**MONTGOMERY COLLEGE - OFFICE OF PROCUREMENT
GERMANTOWN CAFETERIA RENOVATION, GERMANTOWN CAMPUS
RFP NO.: E621-008
RFP CLOSING DATE AND TIME: MAY 5, 2021 @ 2:00 PM**

**ADDENDUM #2
Issued: April 27, 2021**

THIS ADDENDUM IS TO PROVIDE ANSWERS TO THE FOLLOWING QUESTIONS:

Drawing Title
SCHEDULES

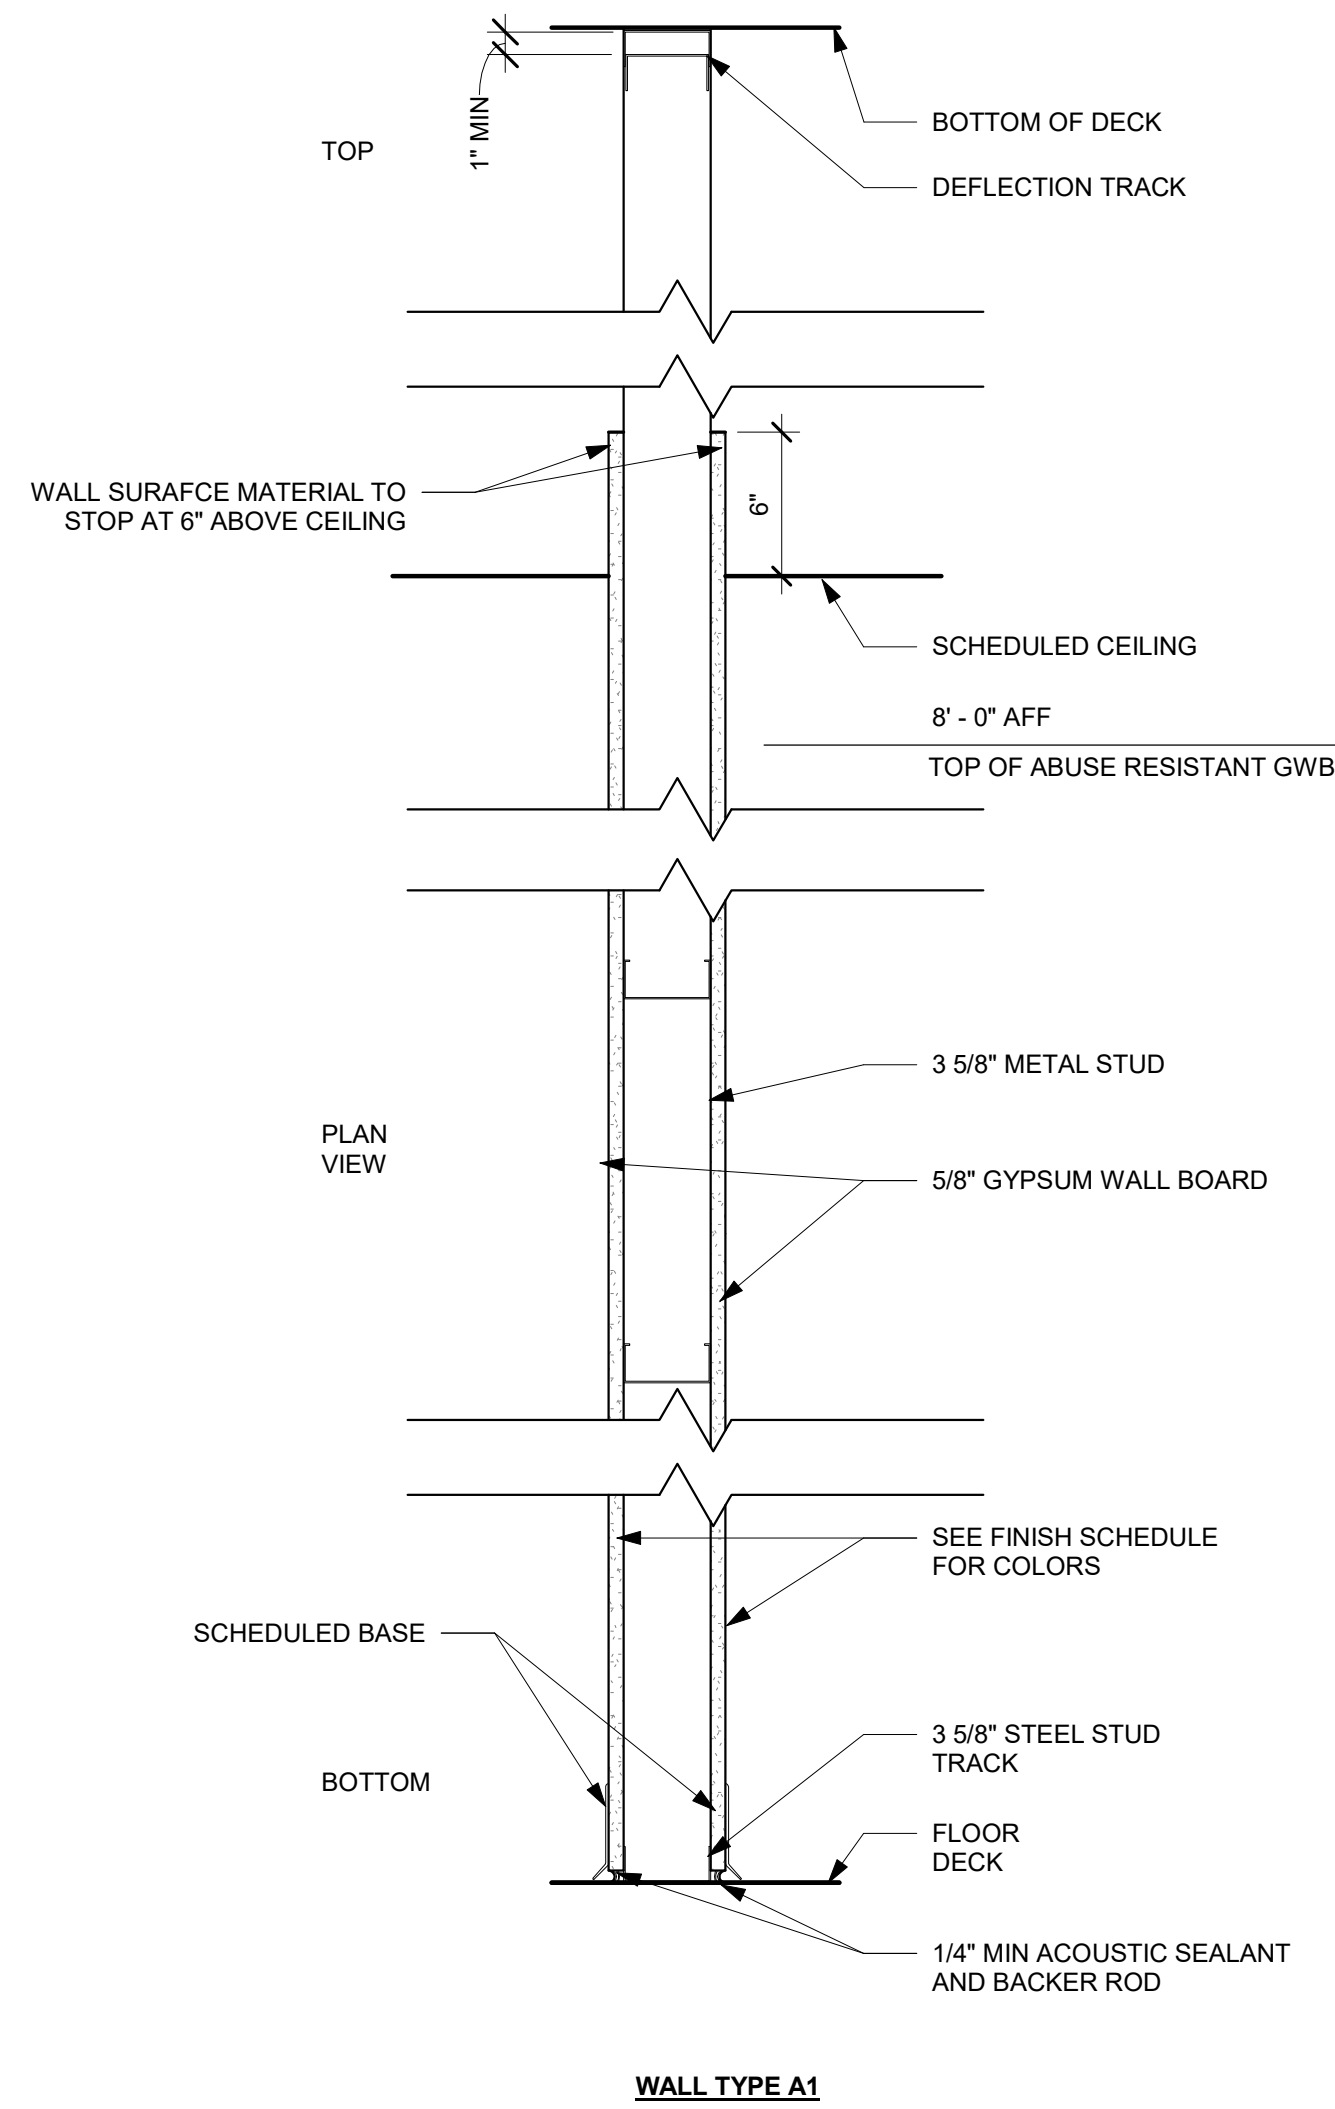
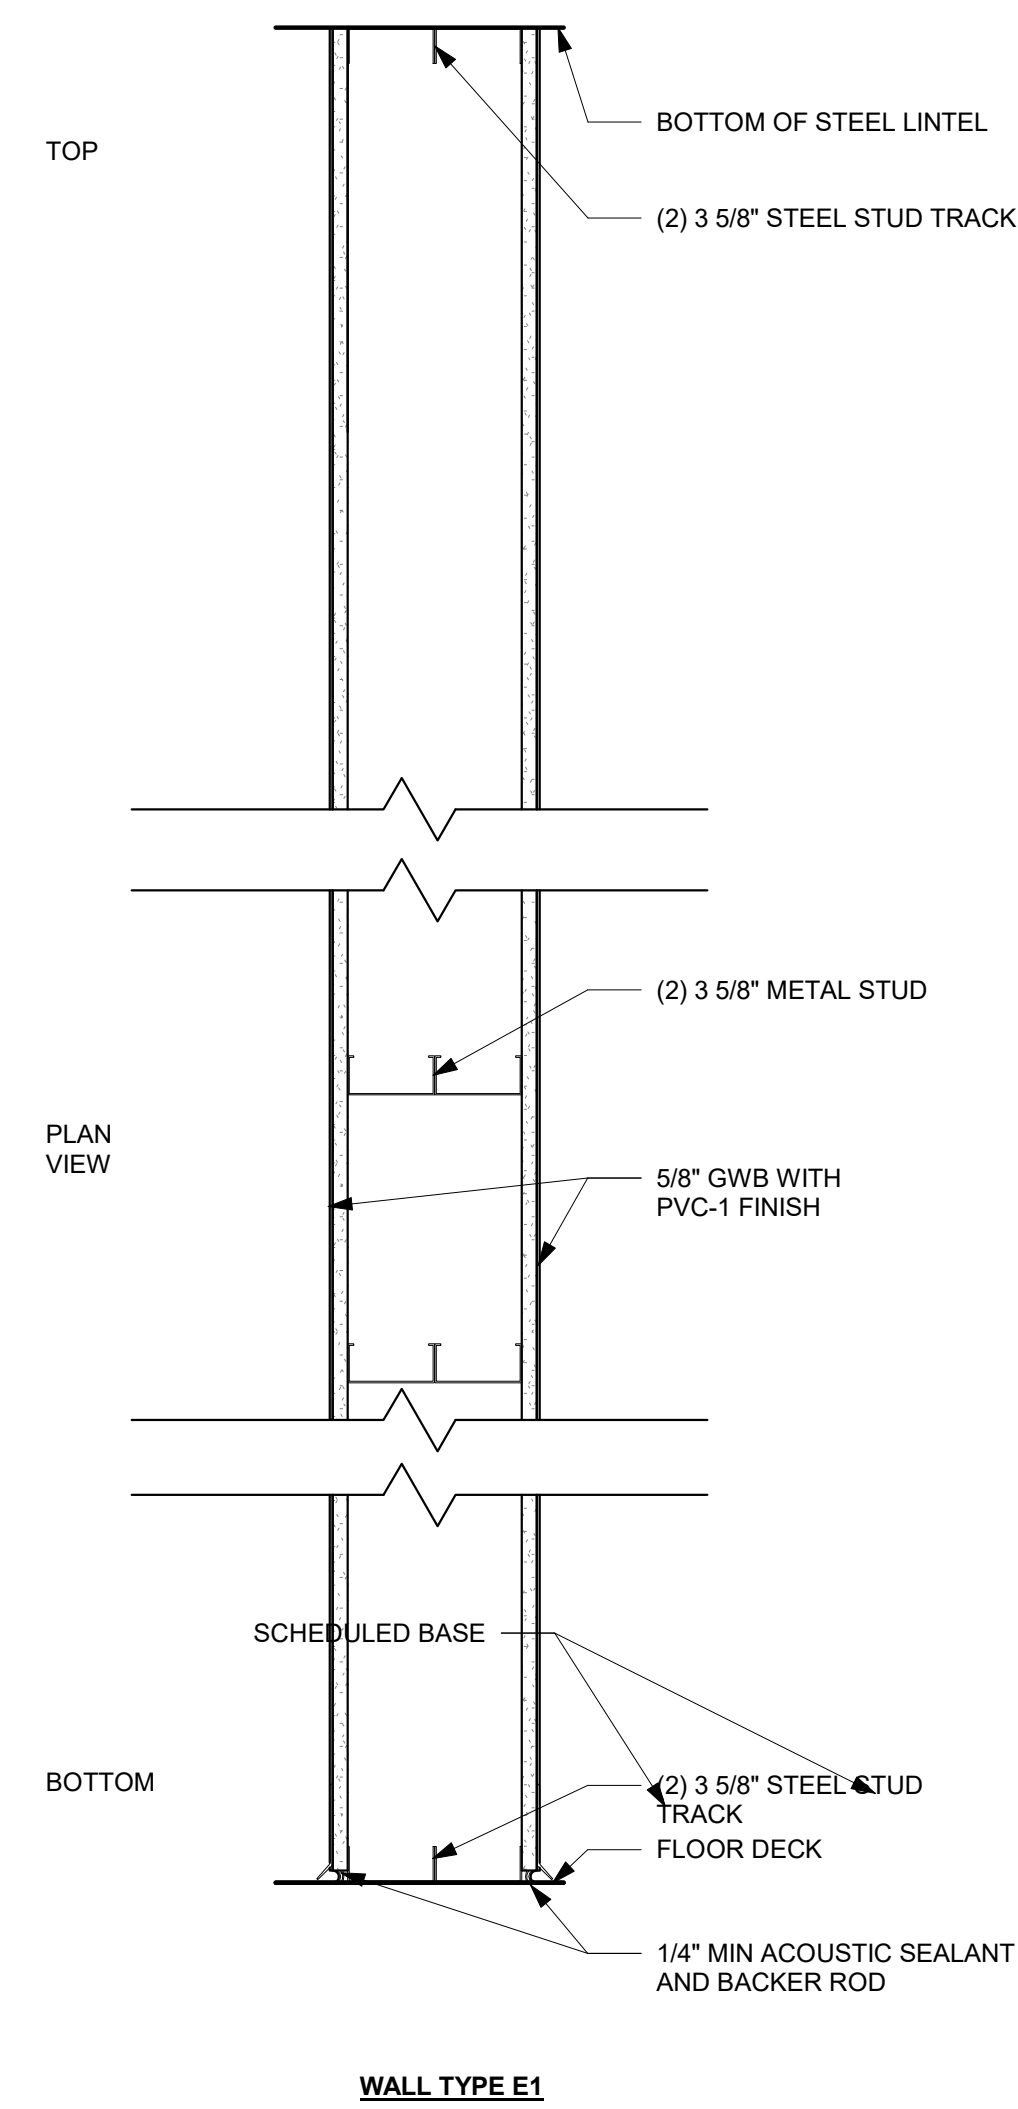
- Item 2-22 Question: Sheet A600/ Room Finish Schedule calls for PTD-2 but is not specified in the specs nor in the finish materials schedule. Please advise.

- Answer: PTD-2 is deleted from the project. Refer to revised A-600.
- Item 2-23 Question: Sheet K002 in the equipment schedule, shows a quantity of 1 GT-1 "Open Air Merchandiser" but the actual equipment plans show (2). Please confirm if one or two GT-1 are to be provided.

Drawing Title
**MECHANICAL PLAN
 EXISTING**

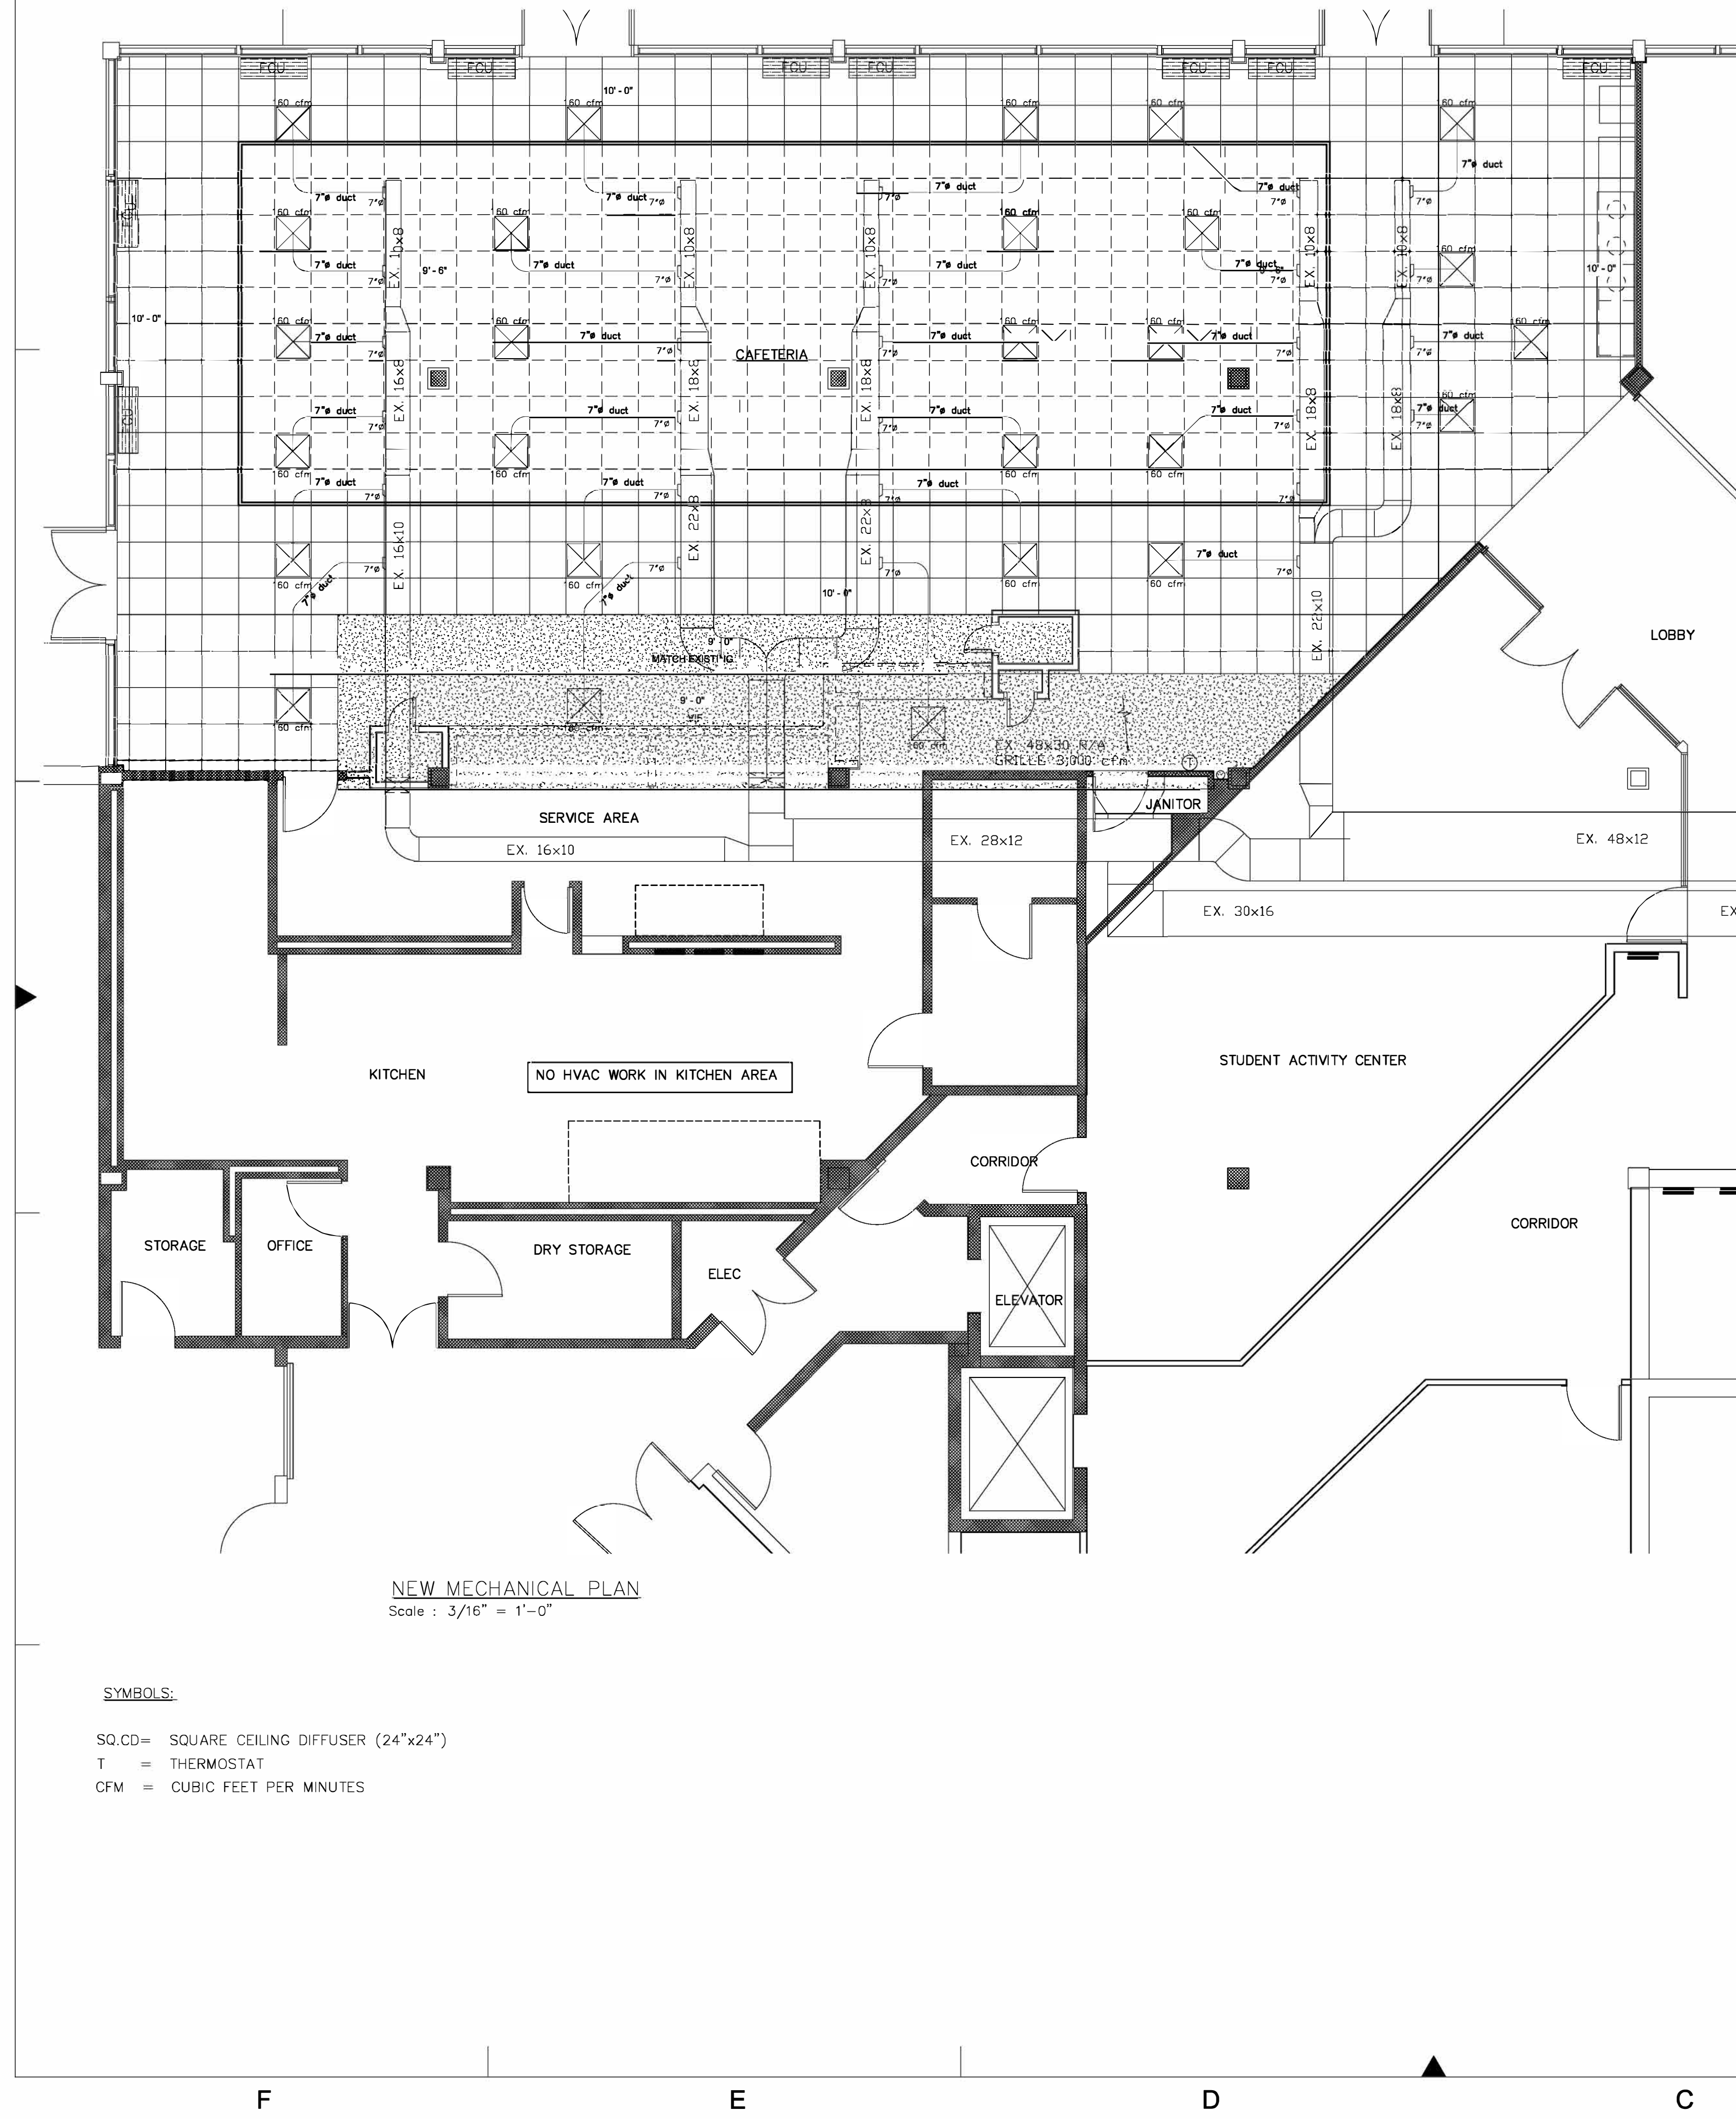
Item 2-5 Question: Note 2 on Drawing M001 reads that new ductwork shall be metal with Insulation. Please advise if it is acceptable to provide an industry standard R4.2 insulated flexible ductwork for at least a minimum of six (6) linear foot for final connection of new metal ductwork to the new supply air device.

Answer: It is acceptable to provide an industry standard R4.2 insulated flexible ductwork for at least a minimum of six (6) linear foot for final connection of new metal ductwork to the new supply air device
